**Town of Kittery  
 Planning Board Meeting  
 May 10, 2018**

**Miller Road – Major Subdivision Sketch Plan Review**

Action: Accept or deny application; Approve or deny sketch plan Owners Paul E. and Peter J. McCloud and Applicant Joseph Falzone requests consideration of a 6-lot conventional subdivision on land along Miller Road (Tax Map 59 Lot 20) in the Residential-Rural (R-RL) and Resource Protection Overlay (OZ-RP) Zones. Agent is Ken Wood, Attar Engineering.

**MILLER ROAD SUBDIVISION  
CUL-DE-SAC SKETCH**  
1" = 50'

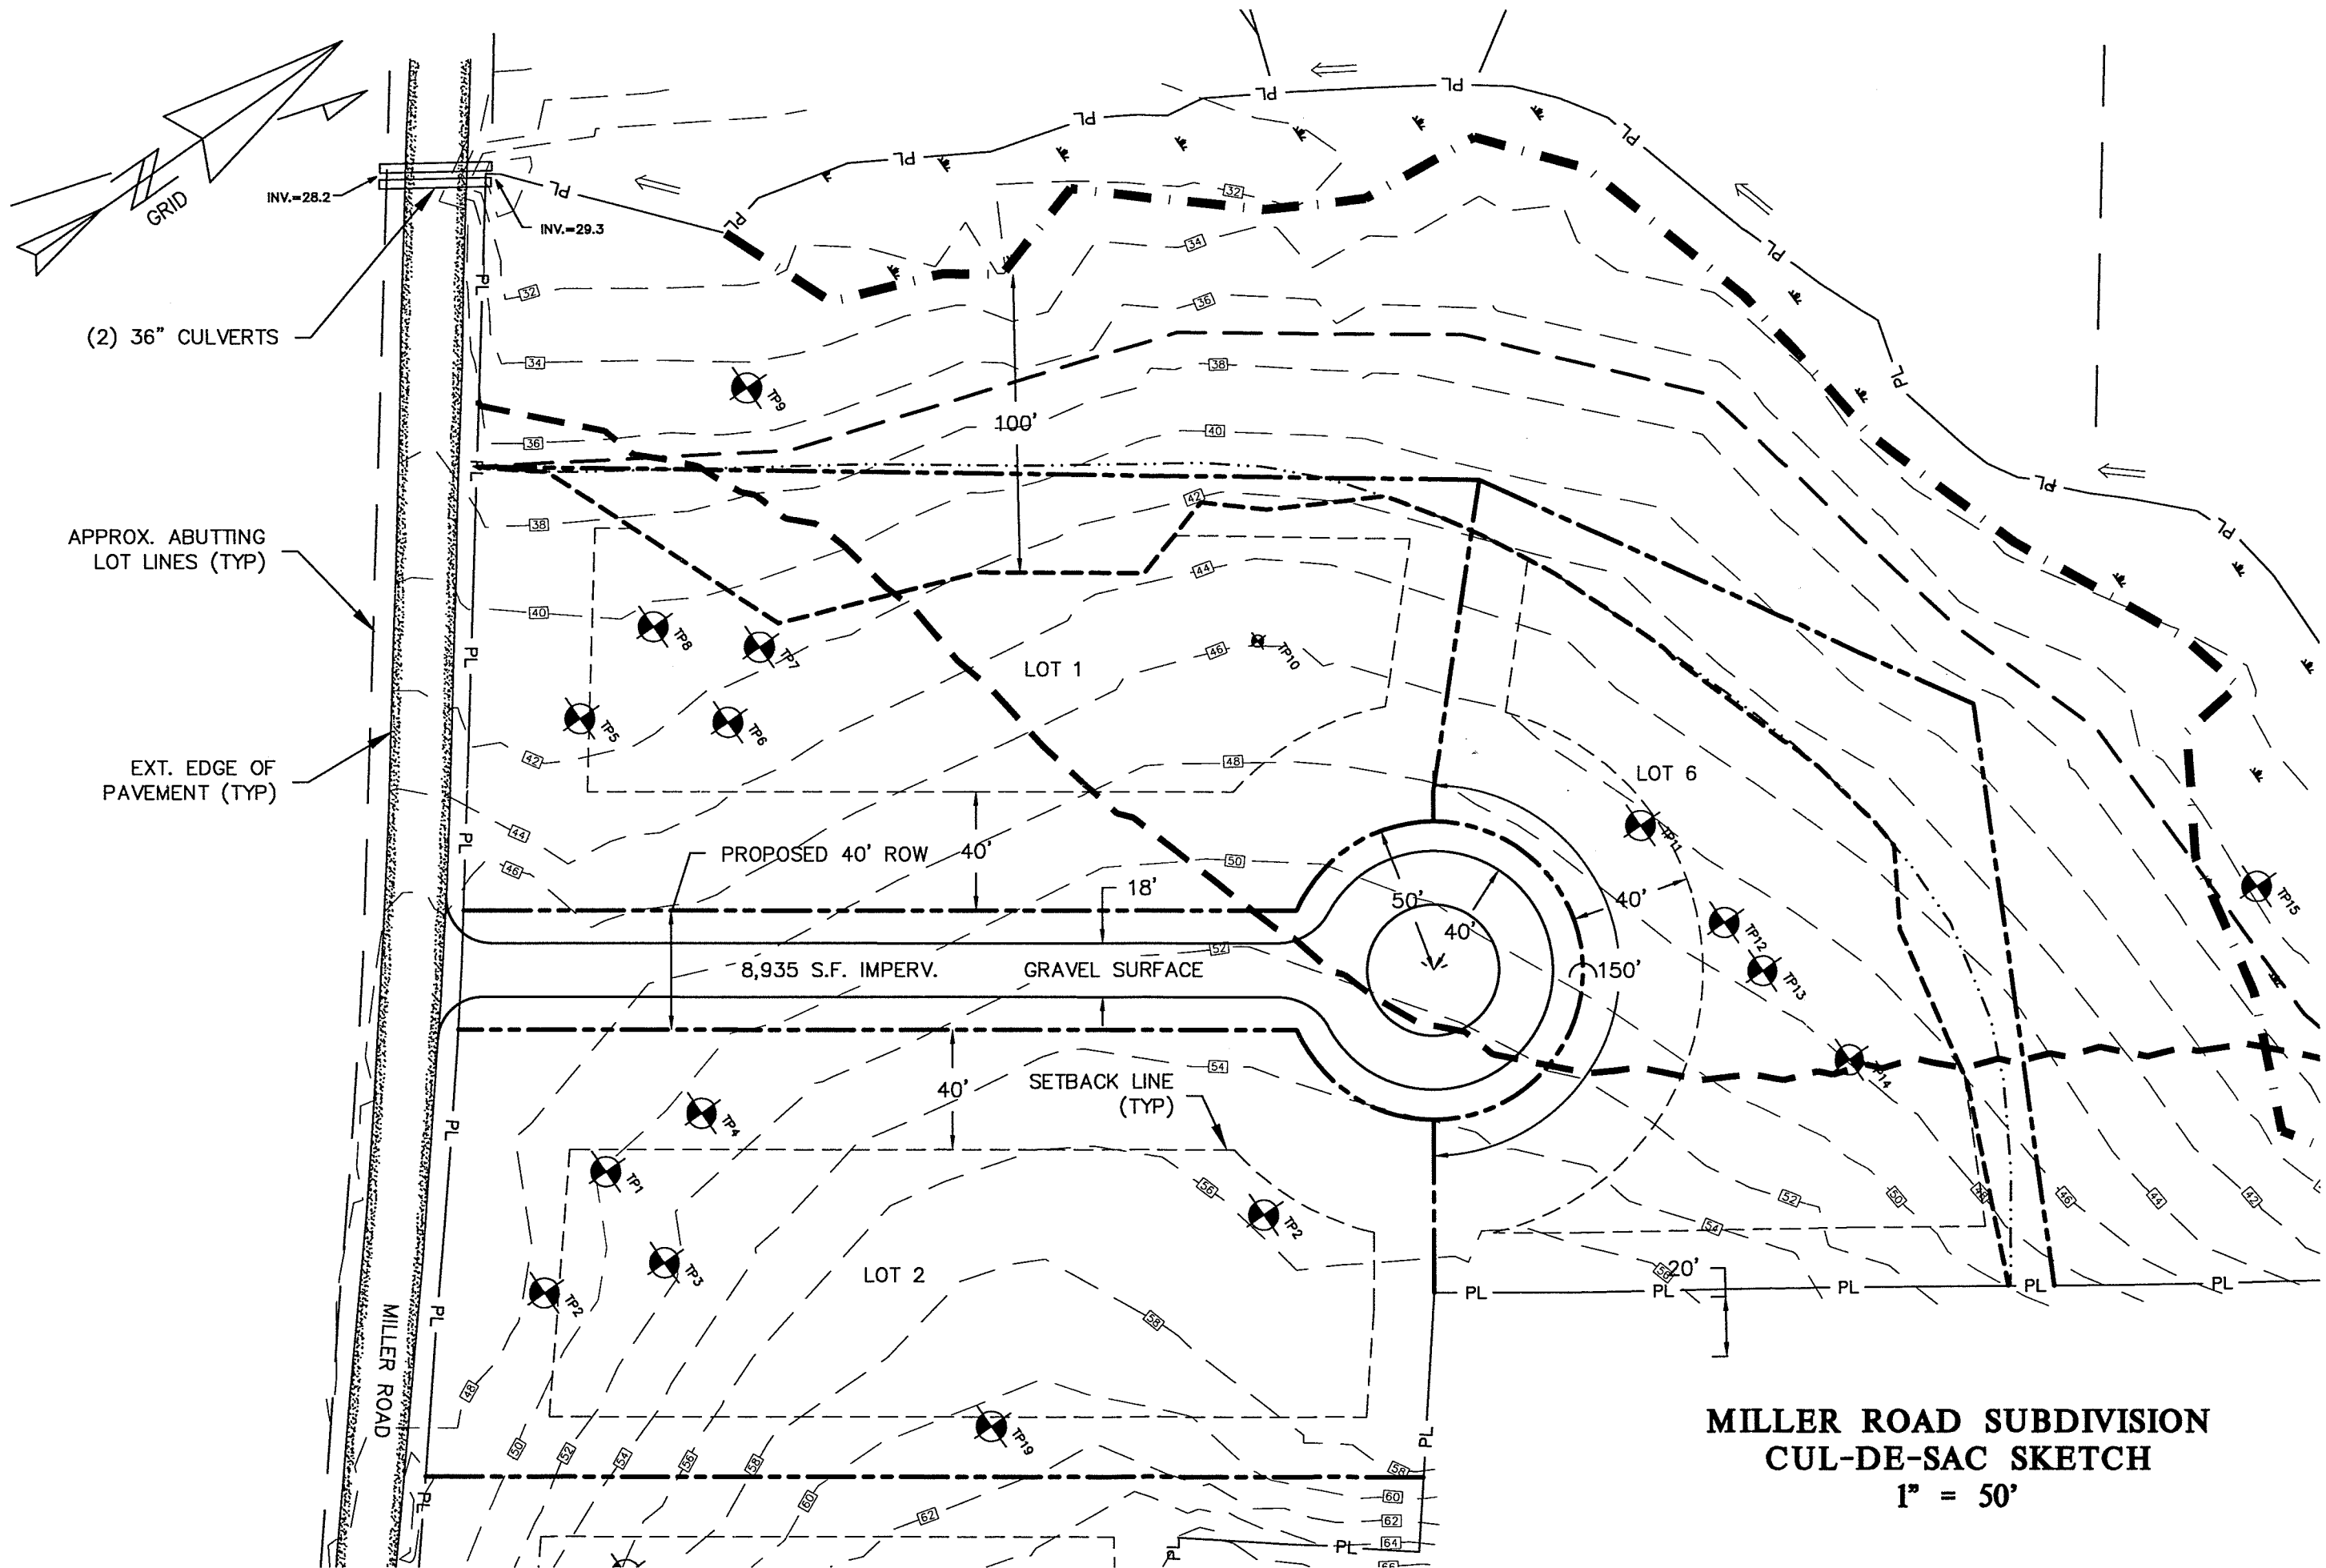
Among the considerations for the Board is whether the design of this subdivision aligns with special exception criteria and the definition of special exception in 16.2. Are there alternatives, for example, such as creating a shorter ROW with a cul-de-sac and deriving frontage from it for Lots 1, 2 and 6? The Board should also discuss the question of conventional vs. cluster and determine if there is information needed from the Applicant before deciding whether or not to grant a special exception use later in the process. Update: the Applicant has presented the Board with three designs in this submission and flagged the centerline of the roads for all three designs at the site walk.

MILLER RD SUBDIVISION.  
CLUSTER DESIGN  
N.T.S.

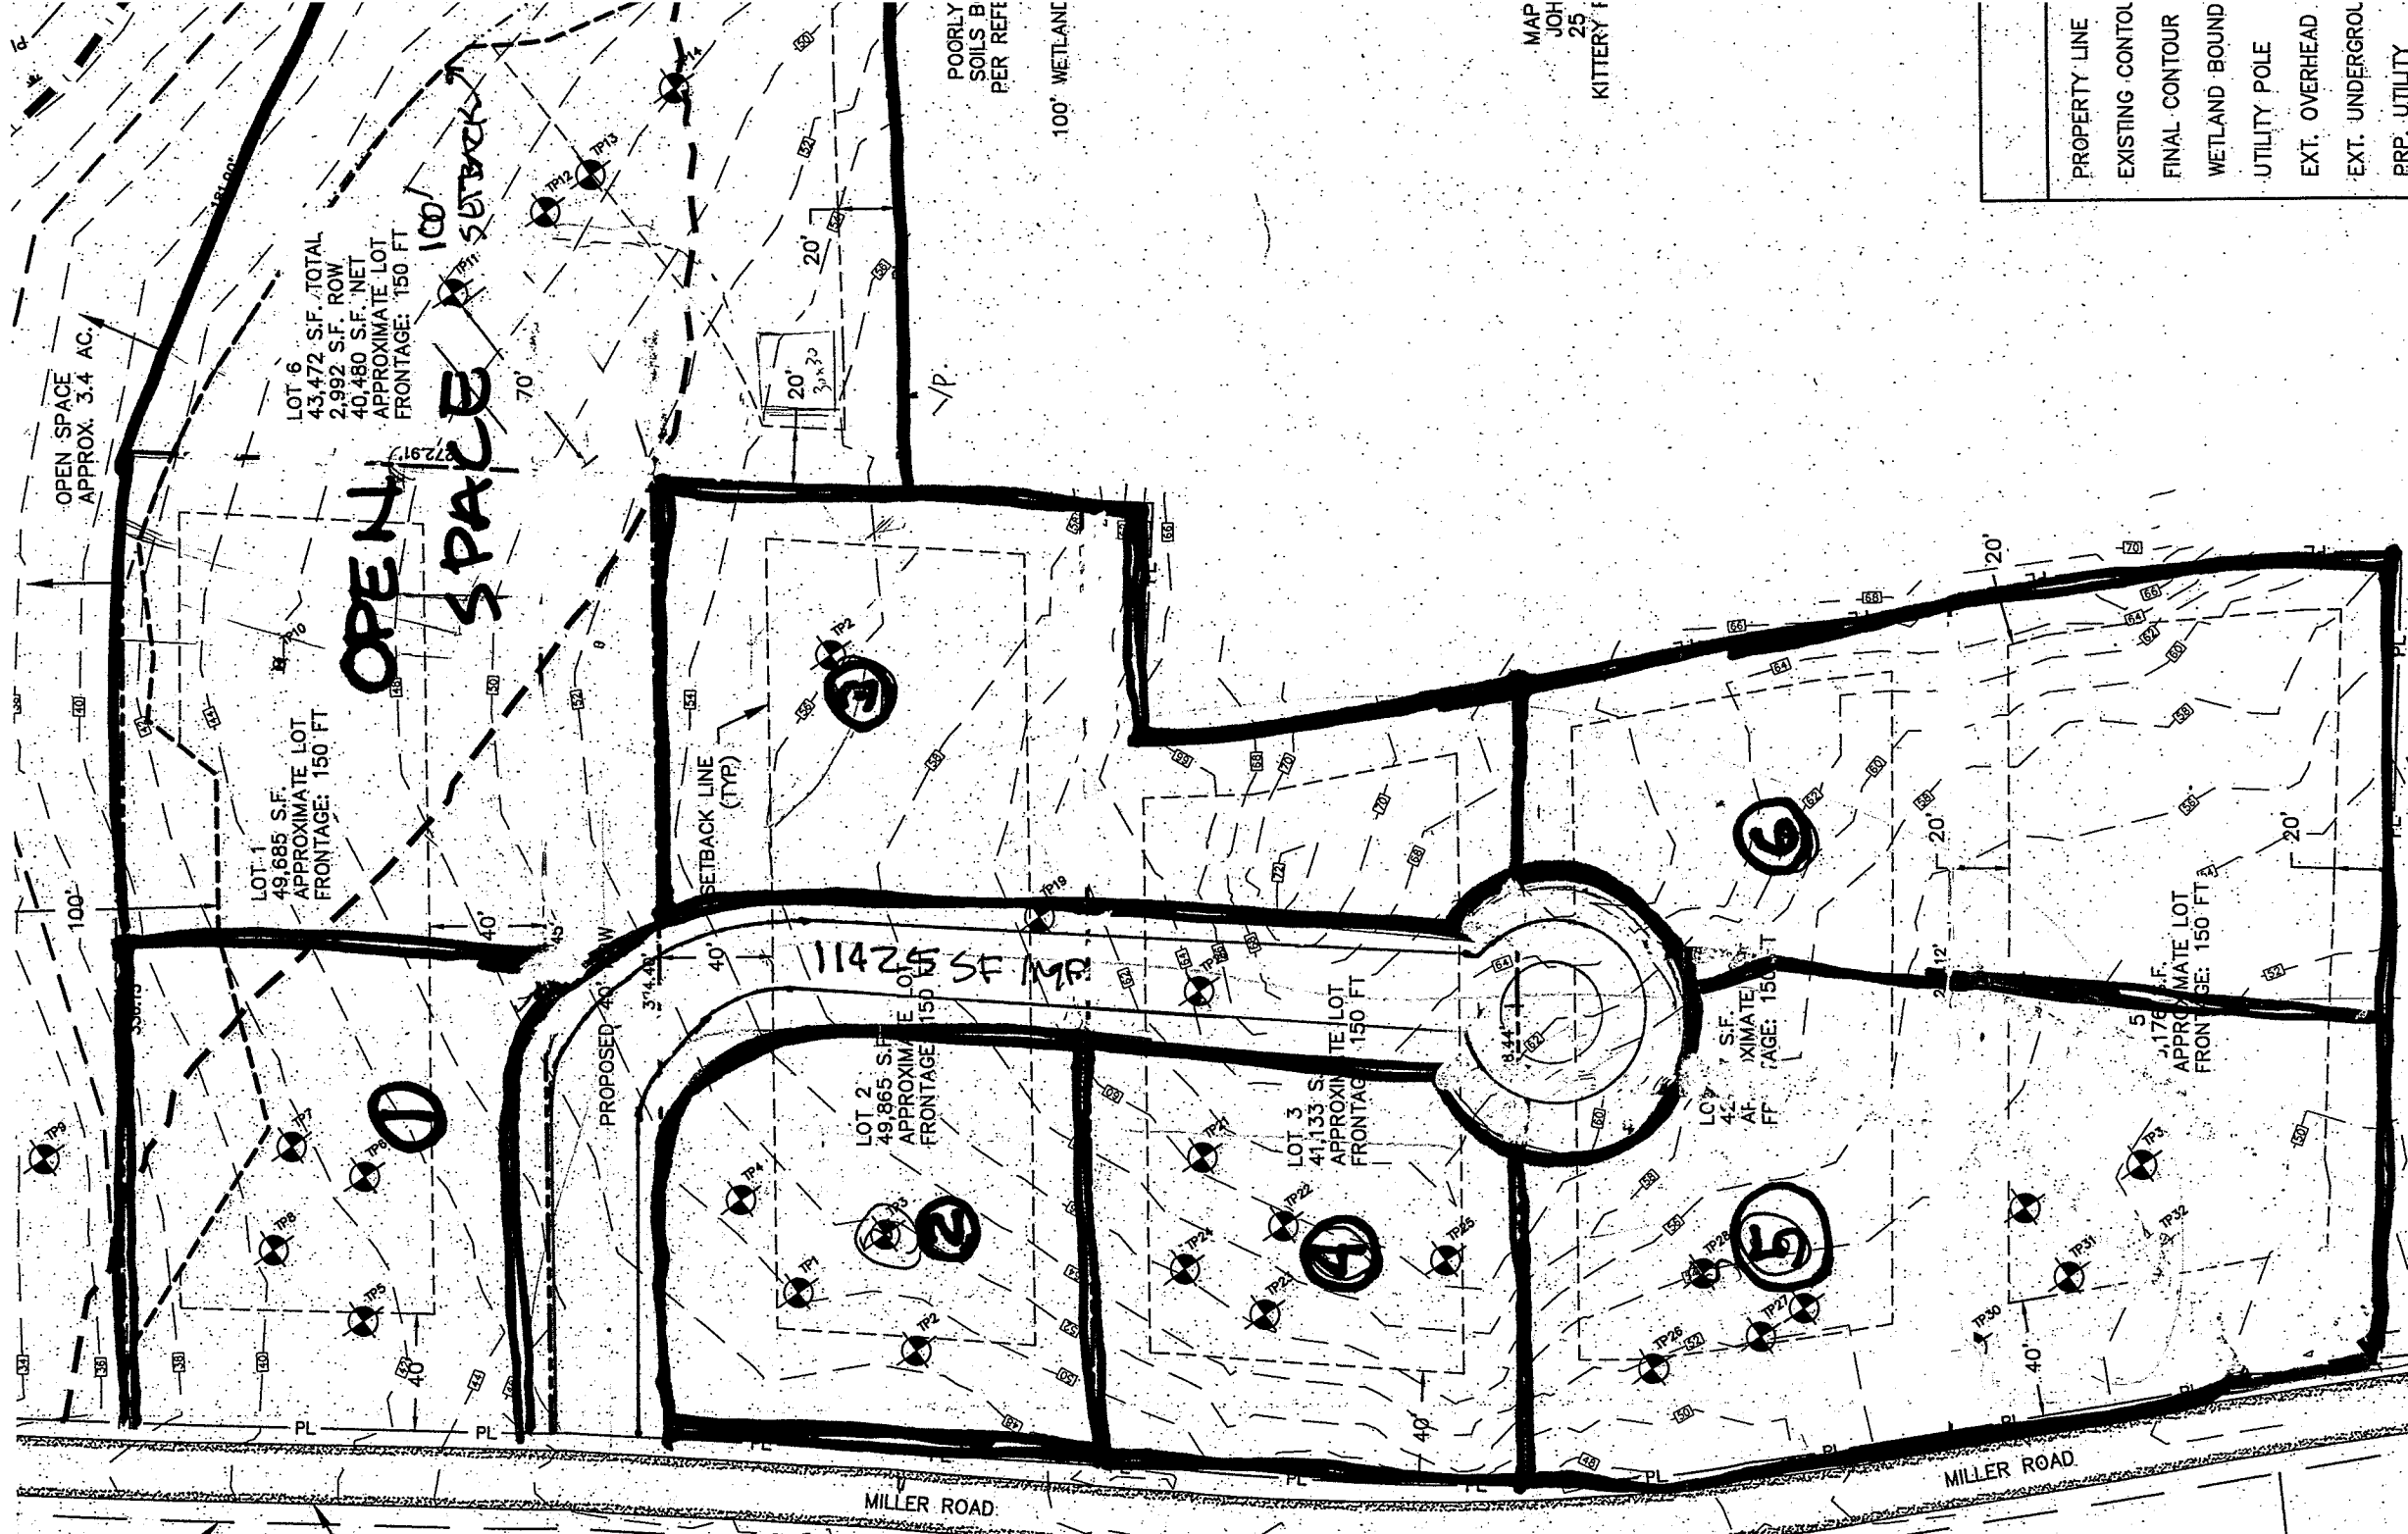
8. **Road Standards.** All plans submitted show a 40-foot ROW (the cluster does not clearly indicate the ROW width but it appears to be 40 feet). Two designs would require a Class 1 Private Street which requires a 40-foot ROW, an 18 foot gravel travel way and 5 foot sidewalks or pedestrian ways. The cluster design would require a Class II Private Street, 20 feet wide and paved, with 5-foot sidewalks/pedestrian ways.
